Access Compliance Report

Public Rights-of-Way

(Curb Ramps)

Intersection ID: 48582	Main Street: WATERLILY_LN	Cross Street: SWEET_FLAG_CT	Location: NW
ADA ID: 591C773D5877	Ramp Type: BlendTrans1	Initial Pass/Fail: Fail	Overall Compliance: No
Severity Score: 8.75			
Codes/Mitigation Info/Possible Solution		Field Measurements/Component Compliance

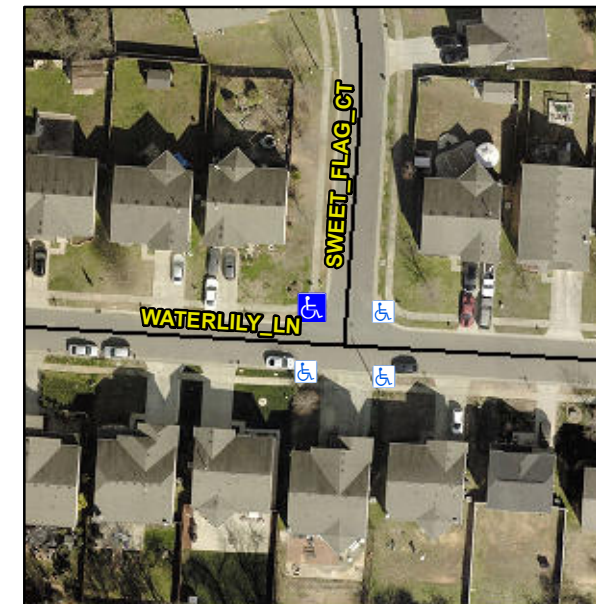
R304.5.1

Compliance	Description	Data	Compliance	Description	Data
N/A	Ramp Length (in)	49.0	Yes	BlendTrans Slope (%)	3.7
No	Ramp Width (in)	40.0	Yes	BlendTrans XSlope (%)	0.6
N/A	Flare Type LT	N/A	N/A	Flare Type RT	N/A
N/A	Flare Slope LT (%)	N/A	N/A	Flare Slope RT (%)	N/A
N/A	Flare Traversable LT?	N/A	N/A	Flare Traversable RT?	N/A
N/A	Landing Length (in)	N/A	N/A	DWS Provided?	N/A
N/A	Landing Width (in)	N/A	N/A	DWS Contrast?	N/A
N/A	Landing Slope (%)	N/A	N/A	DWS Length (in)	N/A
N/A	Landing X Slope (%)	N/A	N/A	DWS Full Width?	N/A
N/A	Landing Curb? (Y/N)	N/A	N/A	DWS Offset (in)	N/A
N/A	Shared Landing?	N/A			
N/A	Gutter Ponding?	N/A	N/A	Gutter Slope (%)	N/A
N/A	Gutter Lip Ht (in)	N/A	N/A	Gutter X Slope (%)	N/A
N/A	Painted X Walk1?	No	N/A	Painted X Walk2?	No
	X Walk 1 Direction	To S		X Walk 2 Direction	To E
	X Walk 1 Width (in)	N/A		X Walk 2 Width (in)	N/A
	X Walk 1 Slope (%)	3.9		X Walk 2 Slope (%)	3.8
	X Walk 1 X Slope (%)	2.5		X Walk 2 X Slope (%)	1.7

N/A	Ramp inside XWalk1?	N/A	N/A	Ramp inside XWalk2?	N/A
	Road Slope (%)	0.3		Clear Space?	N/A
	Road X Slope (%)	3.7	N/A	Clear Space to XWalk (in)	N/A
N/A	Any Obstructions?	N/A	N/A	Storm Grate/Utility Hazard?	N/A
	Obstruction Type			Storm Grate/Utility Type	
		N/A			N/A
			Yes	Surface Condition? (G/P)	Good
			N/A	Curb Slope (%)	N/A

Remove & Replace Curb Ramp With Two New Directional Ramps or Equivalent.
